REPORT FOR CONSIDERATION AT PLANNING SUB-COMMITTEE

Reference No: HGY/2018/3112

Address: Earlham Primary School Earlham Grove N22 5HJ

Proposal: Demolition of existing main school block, and construction of replacement part one, part two-storey school block with associated hard and soft landscaping. Construction of temporary school playground during the course of the construction period only.

Proposed elevation:

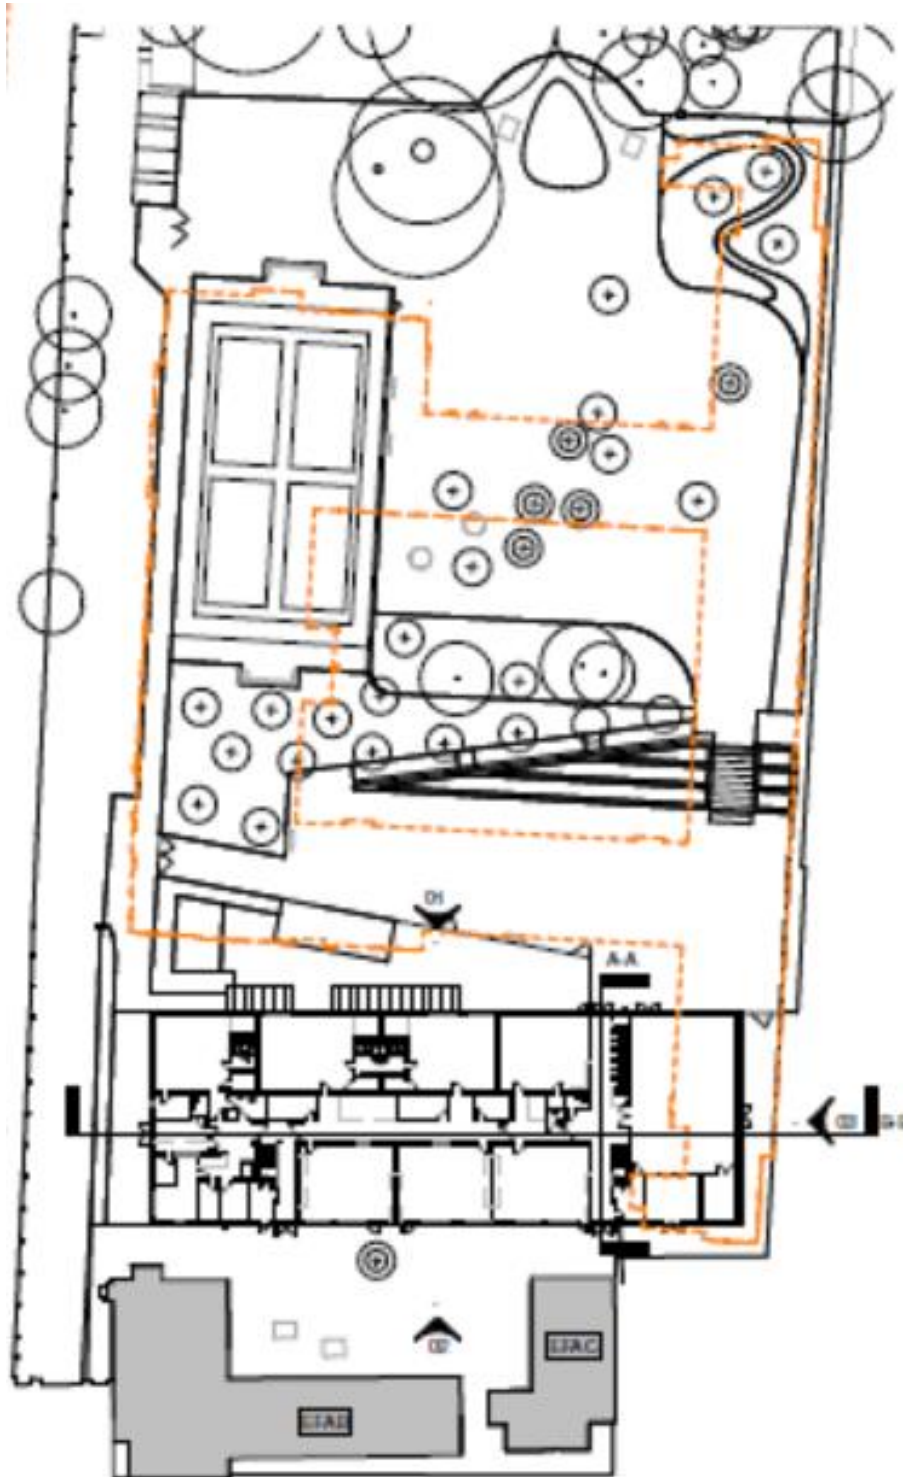
<p>The panel considers that render should be avoided, as it will quickly deteriorate.</p>	<p>While rendered schemes have failed in the last decade, these have often been painted rendered solutions applied to traditional builds. With this being a modular build, the structure is erected in factory controlled conditions, meaning less room for human error, unsavoury building conditions or poor on-site workmanship. Through-Colour render adds the colour to the render as it is being manufactured, meaning that there will be no fading of the colour over time. While we agree that some rendered schemes have failed historically, this should not discount render from all schemes in perpetuity. This approach is necessary given the modular build.</p>
<p>Whilst a pastiche approach is not appropriate, clues to the</p>	<p>The materiality proposed is reflective of the area, with a London stock brick</p>

<p>contemporary design and character of the new building could be taken from the rich brick detailing of the former Caretaker's House. The street frontage proposed is particularly uninspiring. This should be more prominent and welcoming, perhaps with a canopy over the entrance, and carefully integrated with the associated hard landscaping.</p>	<p>and light render (amended since the QRP) strongly represented in the locality (see London Stock and rendered buildings on Earlam Grove).</p> <p>Secondly, the use of render allows the design to become more playful and reminiscent of a school with muted, yet colourful blue and yellow tones to compliment the London Stock brick proposed.</p> <p>Finally, a generous canopy has been added since QRP to the entrance to create more significance to the school entrance.</p>
---	---
